TITLE ALL−03 USB adapter	
FILE: all−03−usb.sch	REVISION: 0.0 (04−Jan−2014)
PAGE 1 OF 1	DRAWN BY: Michael Kukat

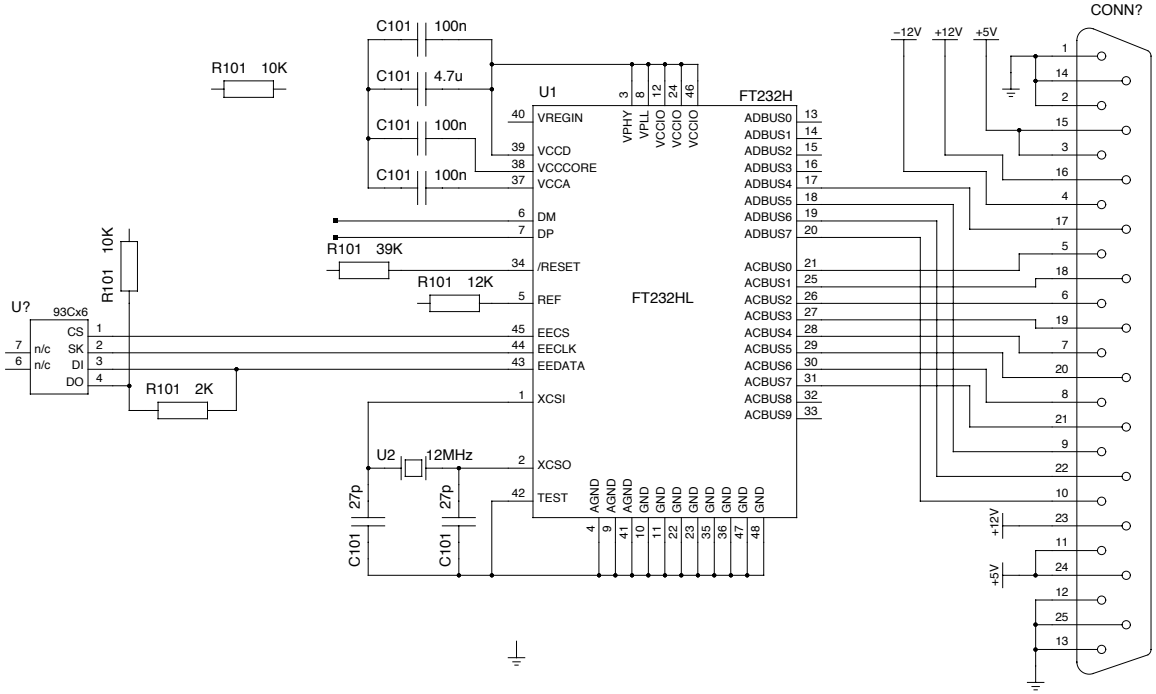
R101 needs to be 1%

Place all power related capacitors close to the VCC pins
